670026

SPECIAL 1/4" DIAPHRAGM PUMP

GENERAL DESCRIPTION

PN 97999-1021

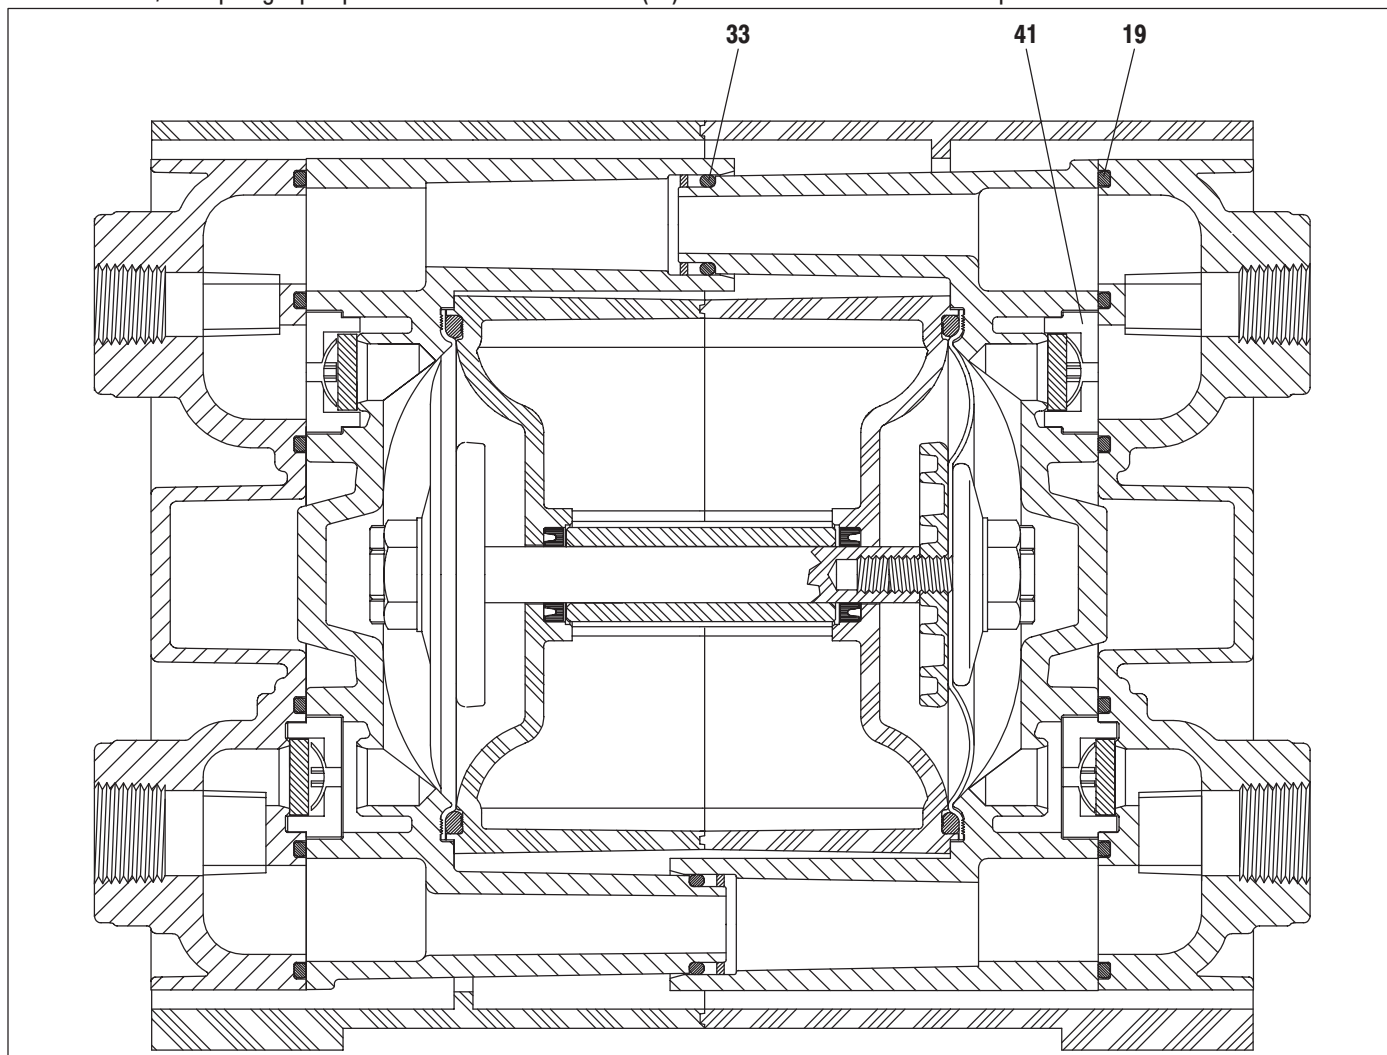
The standard 1/4" diaphragm pump is modified to include Teflon (19)

seals, Teflon (33) "O" rings and Acetal (41) spring stops. Follow the standard parts list for model PD02P-APS-PTA with the exception of the items listed below.

MODEL	"19"			"33"			"41"		
	Seal	Qty	[Mtl]	"O" Ring (.103" x .693" o.d.)	Qty	[Mtl]	Spring Stop	Qty	[Mtl]
PD02P-APS-PTA	94434	(4)	[E]	94437	(2)	[E]	93814-1	(4)	[P]
670026	94435	(4)	[T]	94438	(2)	[T]	93814-2	(4)	[D ₁]
